## TECHNICAL NOTE

Project: DM/25/2634 - Batchelors Farm, Keymer Road – Additional Traffic/Transport Information

STAGE 1 ROAD SAFETY AUDIT  
RESPONSE REPORT

**BACHELORS FARM, KEYMER ROAD  
BURGESS HILL  
S278 WORKS  
STAGE 1 ROAD SAFETY AUDIT**

Scale: 1:1000 (@ A3)  
Drawing: 151112-01  
Revision: -

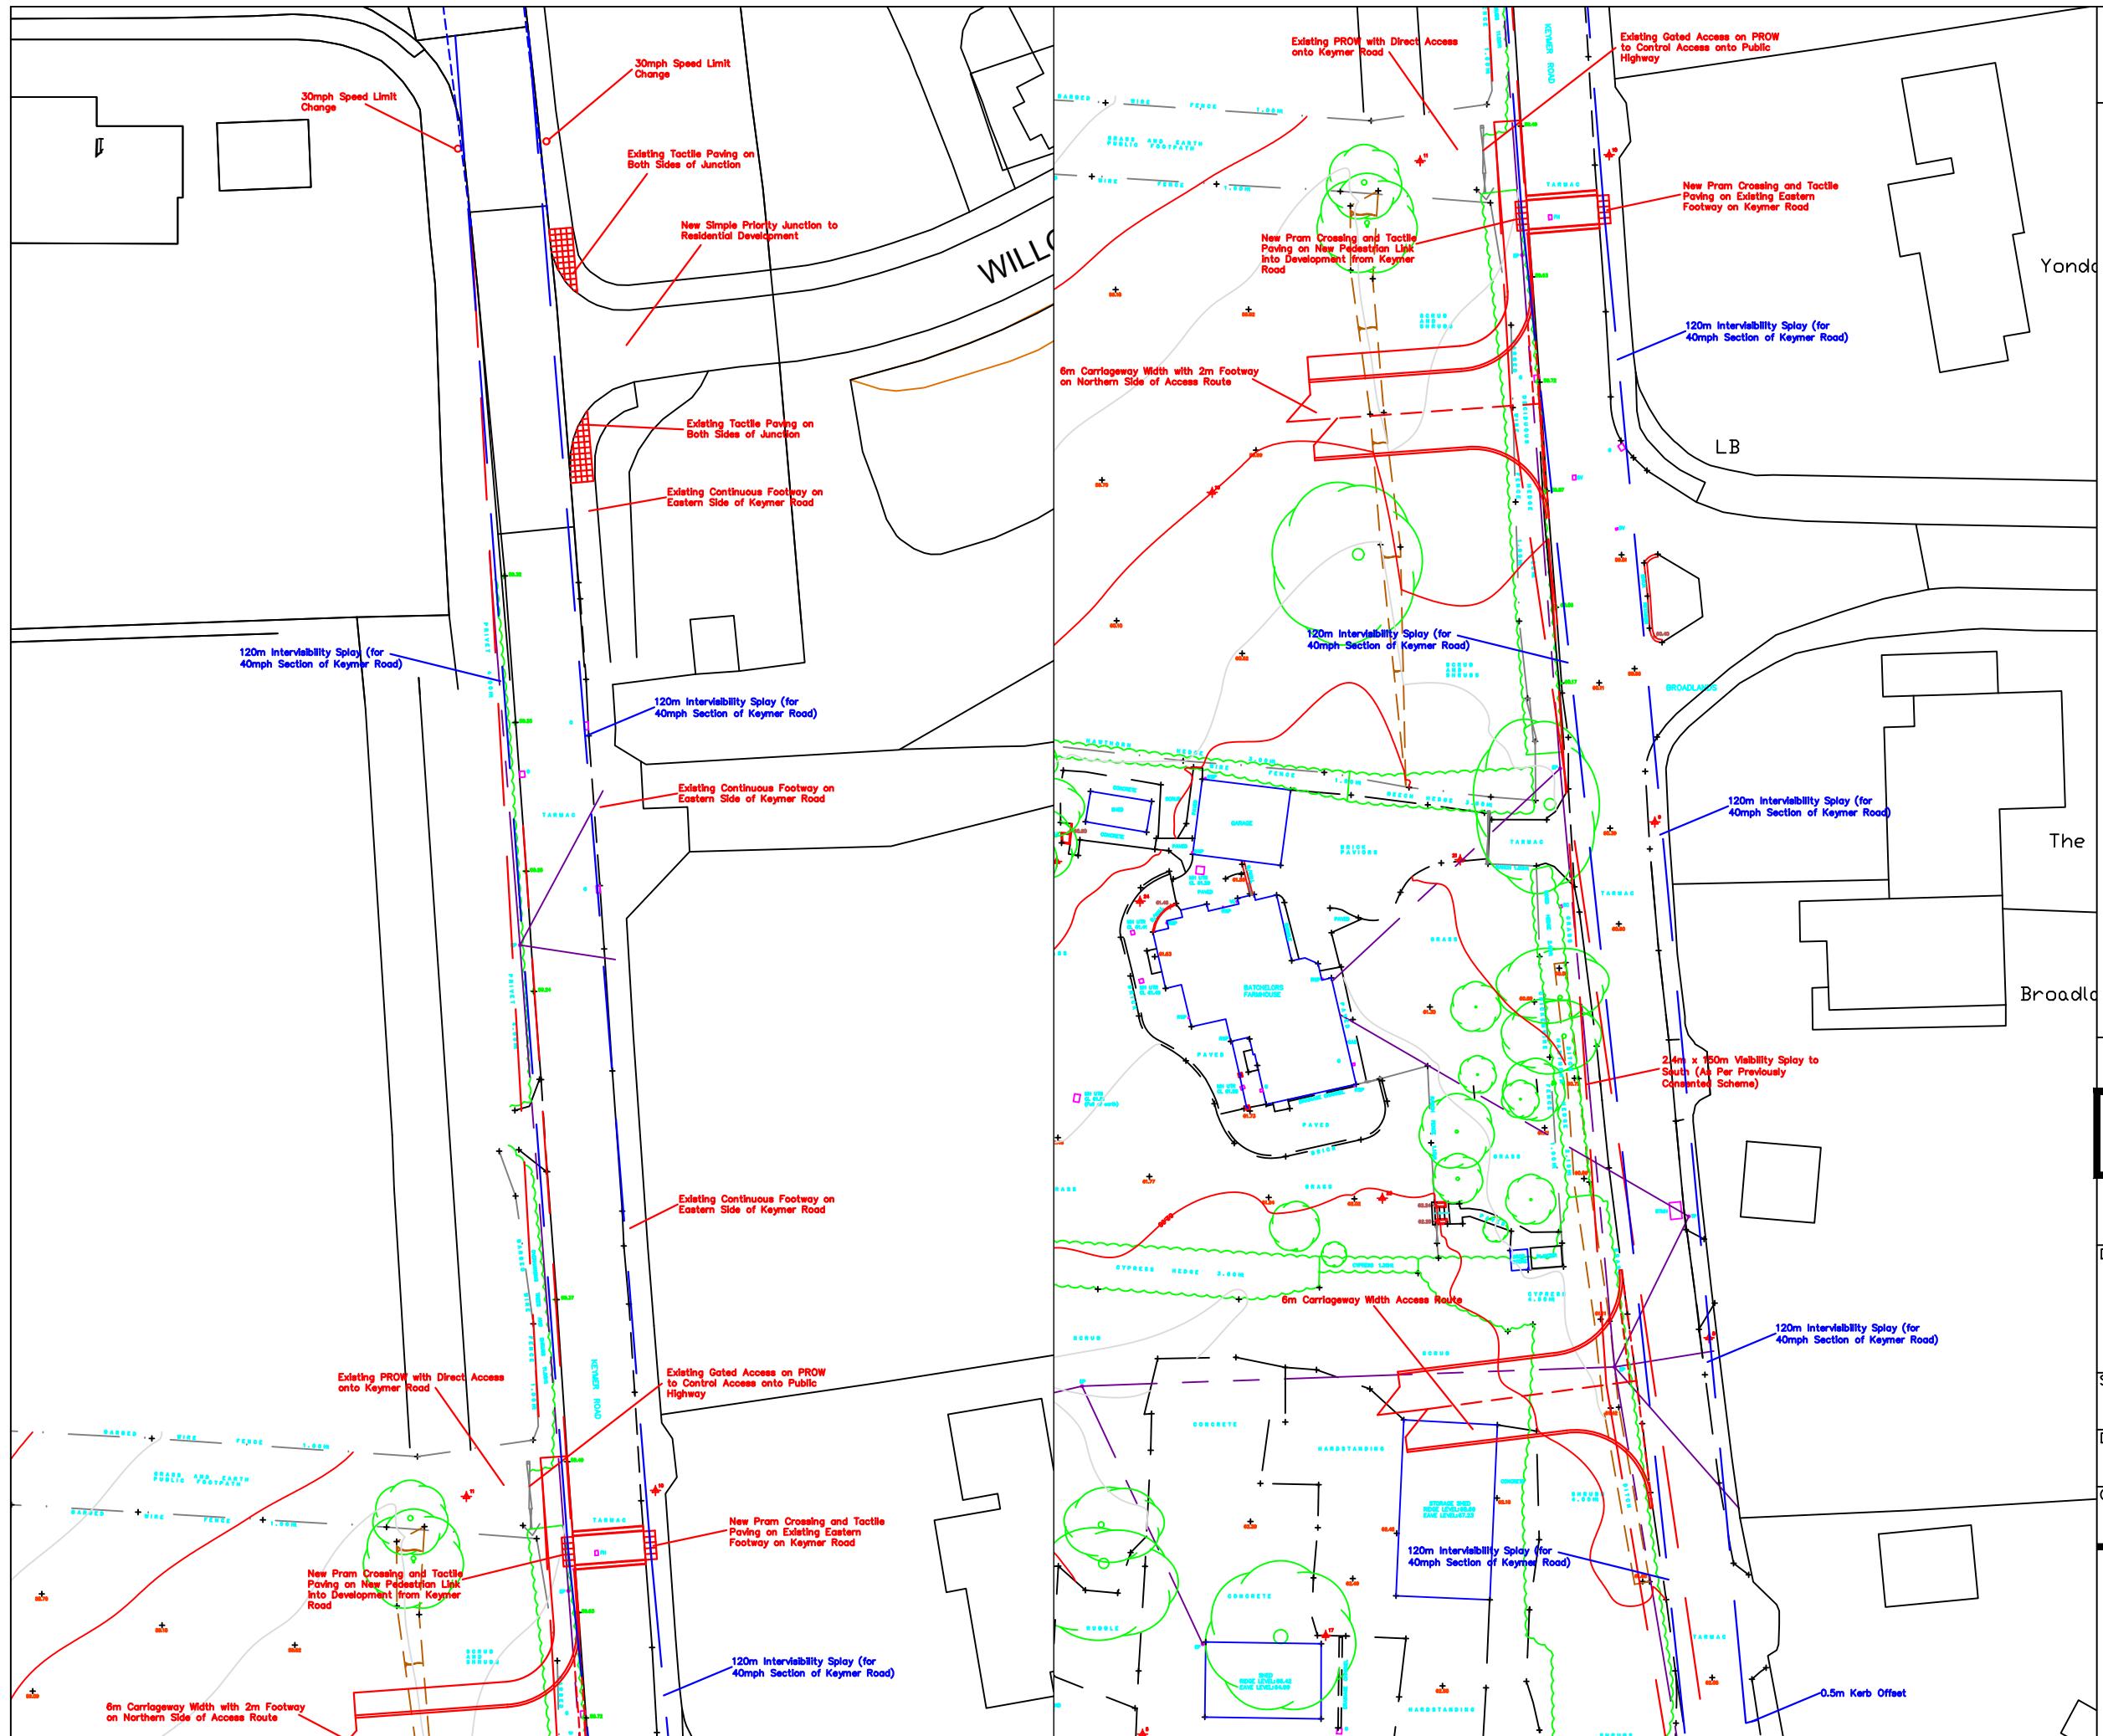
The southernmost access will serve the rest of the site. ATC survey in 2018, when the road was subject to National Speed Limit, revealed 85<sup>th</sup> percentile speeds of 43mph northbound and 42.8mph southbound. Additional ATC in March 2025 revealed 85<sup>th</sup> percentile speeds of 44.4mph northbound and 43mph southbound (with vehicle movements at 619 in AM and 607 in PM peak hours). Previously agreed (DM/15/3955) splays of 2.4m x 120m north and 2.4m x 150m south have been demonstrated at both access points passing through applicant owned land and publicly maintained highway. Based on recorded speeds a requirement of 116m north and 122m south and thus LHA is satisfied with visibility demonstrated on drawing 151112-01 (Proposed Access Location and Visibility Splays).

2.3 The auditors highlighted that the submitted drawings show visibility splays of 2.4m x 140m to the south of the southern junction, and 150m to the north of this junction. The team have highlighted that at the proposed northern access the previously approved visibility splay dimensions have not been notated on the plans.

The scheme drawing indicates visibility splays of 2.4m x 140m to the south of the proposed southern access junction and 2.4m x 150m to the north of the proposed southern access junction. Although visibility splays are indicated for the northern access junction, no values have been indicated on the scheme drawing.

- 2.8 In response to the RSA team's findings, we agree that all previously agreed visibility splays, that are shown on the previously approved 2015 access scheme drawings produced by Motion, and included in appendix j the SKTP Transport Statement will be provided. For ease of reference this drawing is provided again in **appendix c**.
- 2.9 To confirm, the 2015 approved visibility splays were dimensioned as:

- leading traffic direction (south) – 2.4m x 150m
- trailing traffic direction (north) – 2.4m x 120m

- leading traffic direction (south) – 2.4m x 140m
- trailing traffic direction (north) – 2.4m x 150m

- 2.10 We can confirm that the above visibility splays will be delivered at the development site accesses, kept permanently clear of vegetation and obstructions, and maintained in perpetuity. The delivery of these visibility splays (and the site accesses) can be secured through an appropriately worded Planning Condition.

Drawing Number  
**SK21799-10**

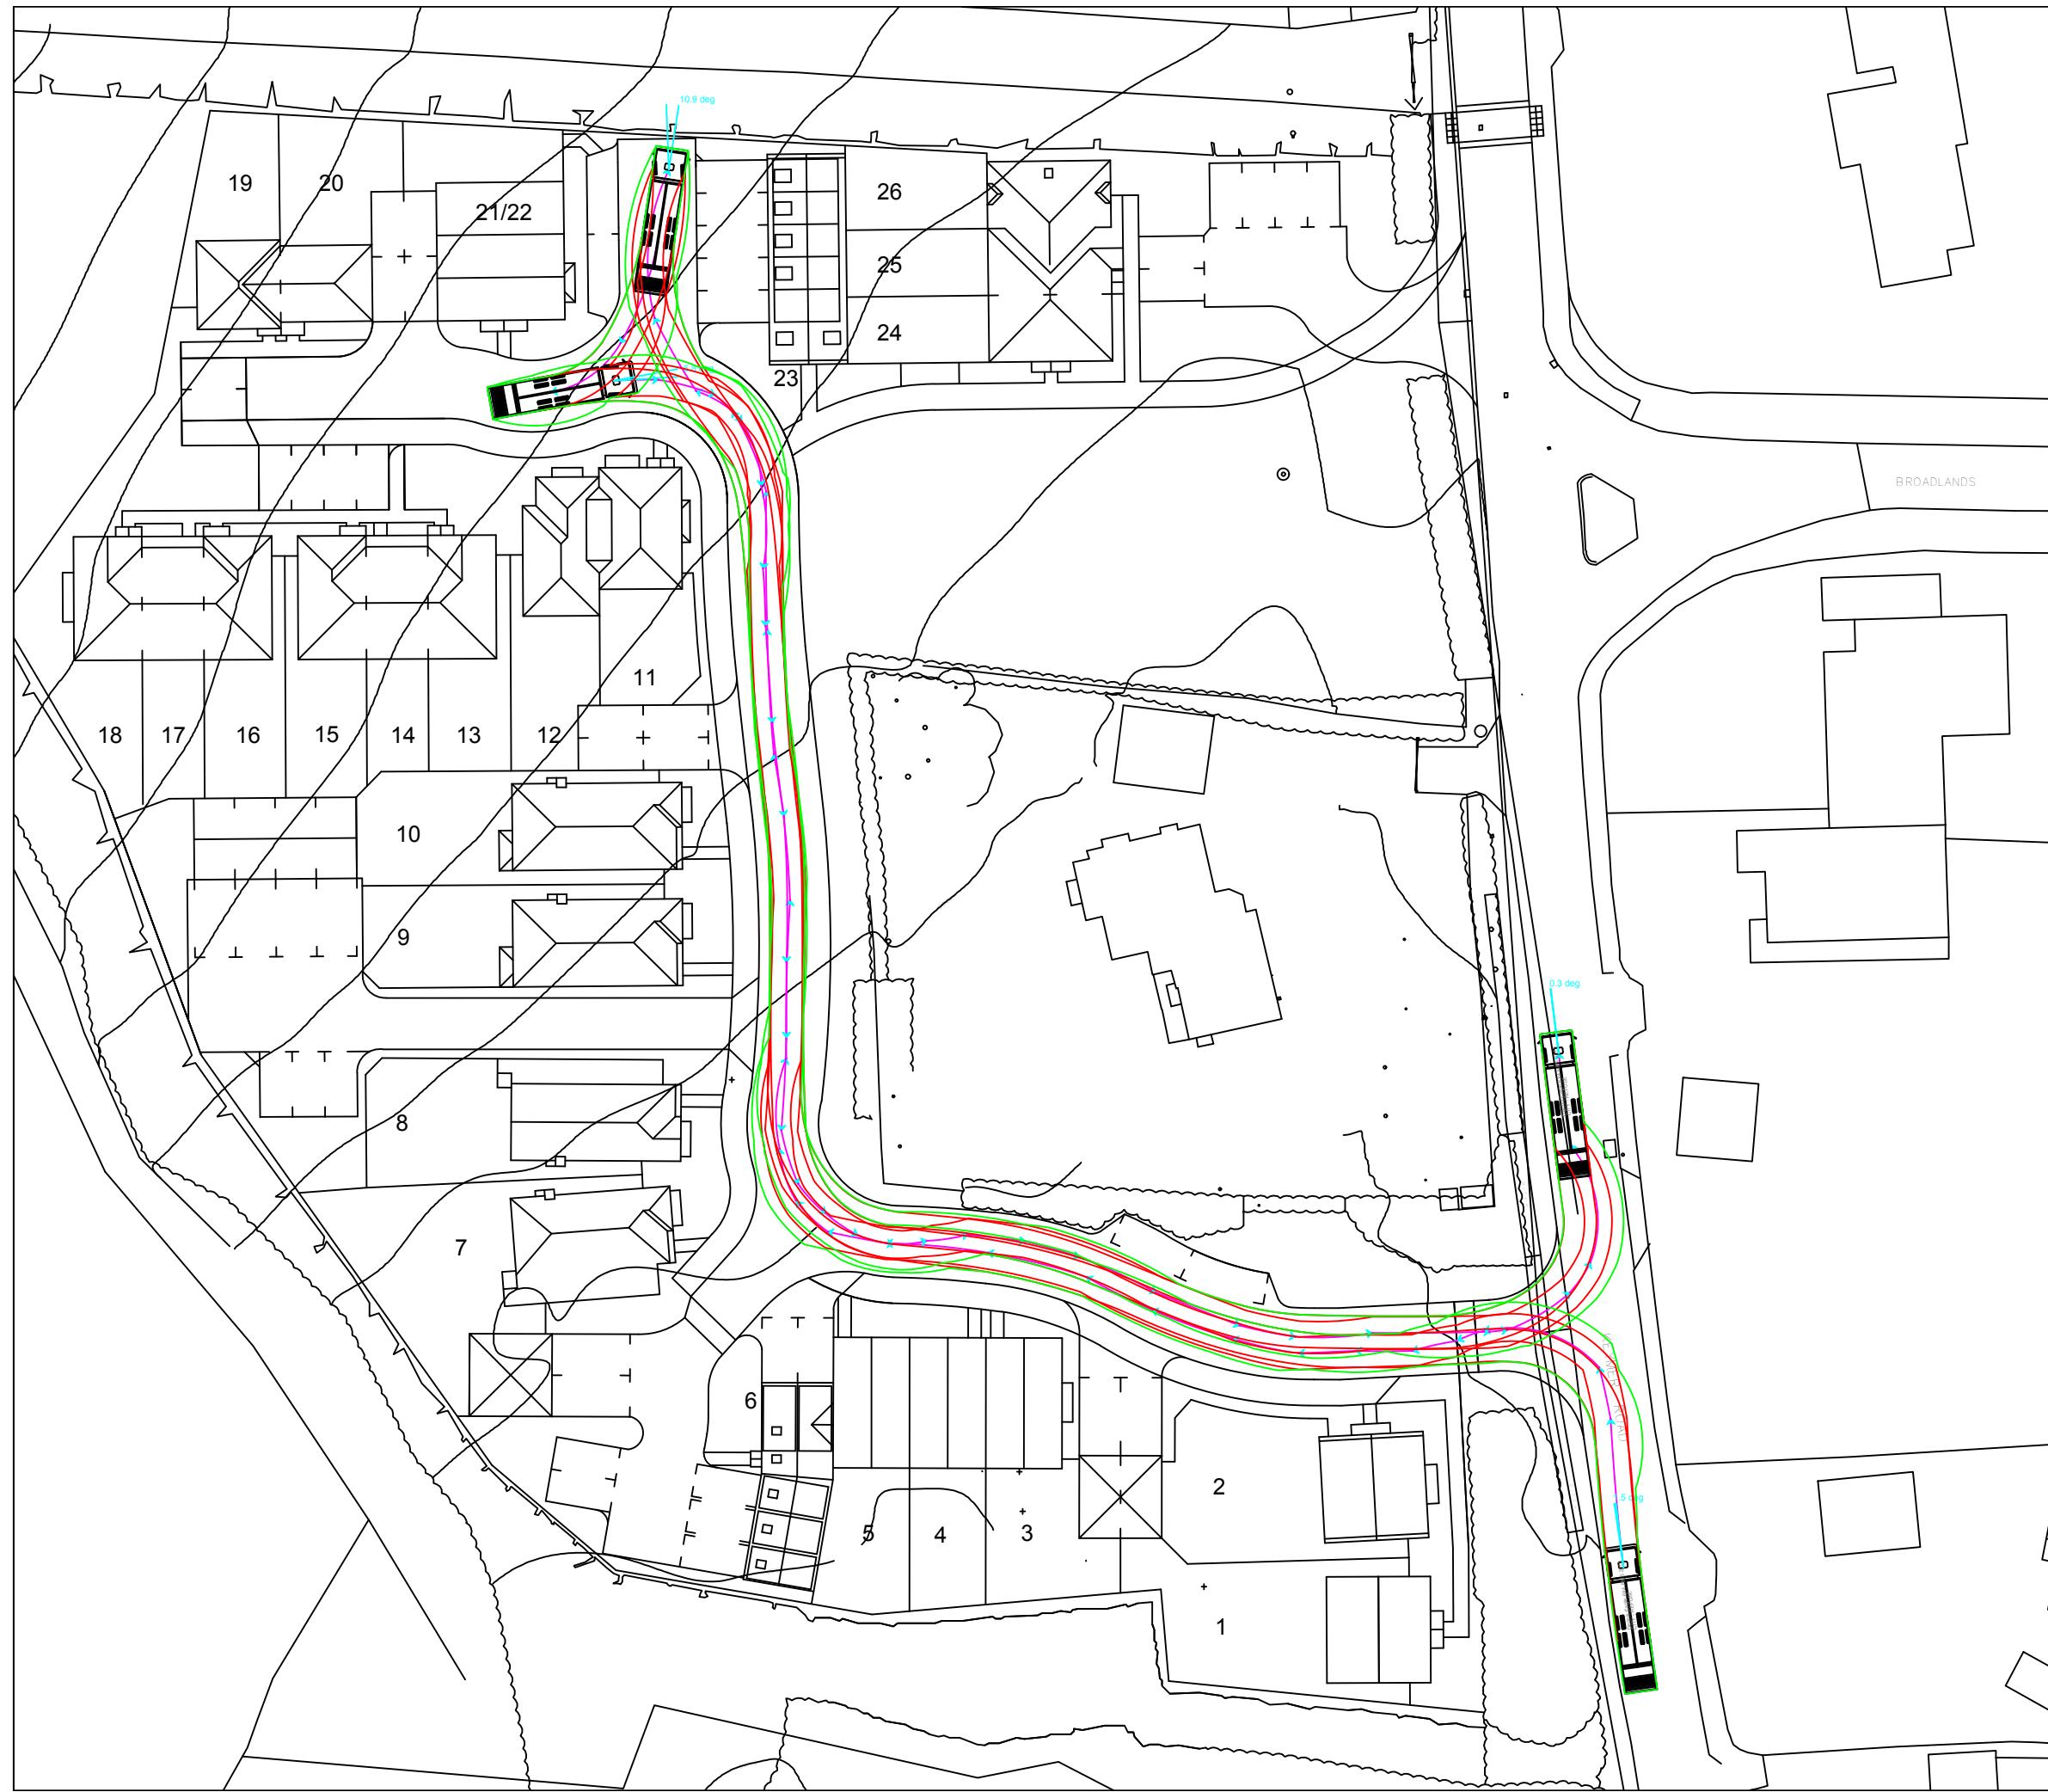
Swept path tracking plans should be provided showing that the vehicle access can accommodate refuse collection and fire appliance vehicles and that these can turn on site to exit in a forward gear.

2.19 The RSA team has recommended that swept path analysis should be undertaken for all the expected types and sizes of vehicles entering and exiting the development site access junctions, in order to mitigate the above described potential collision scenarios. The RSA team has said that if there is any encroachment over centrelines, then junction geometry should be modified in order to mitigate their described potential collision scenarios.

It is recommended that swept path analysis exercises should be undertaken for all the expected types and sizes of vehicles entering and exiting the proposed development site northern and southern access junctions and where required, the access junctions should be modified, in order to mitigate the above described potential collisions scenarios.

2.20 In response to the RSA team's findings, we have prepared a range of swept path analysis drawings, showing refuse vehicle, private car and fire appliance vehicles entering and leaving the site. These tracking plans are provided in **appendix e**.

2.21 In terms of vehicles crossing the centreline of Keymer Road and on the minor junction arms the swept path analysis confirms that all vehicles can enter and leave the site without any wheel overrunning kerbs and grassed areas. The turning areas can all accommodate the refuse and fire appliance vehicles that have been tracked.

2.23 As an example, to accommodate a 11.3m refuse vehicle avoid overrunning the centreline of carriageways a priority junction design would need to be designed with 10m kerb radii, and an internal 6m+ carriageway width. This would, in turn run the risk of higher entry and exit vehicle speeds onto/off Keymer Road, which would have a negative effect on highway safety on the Keymer Road corridor, and within the development.
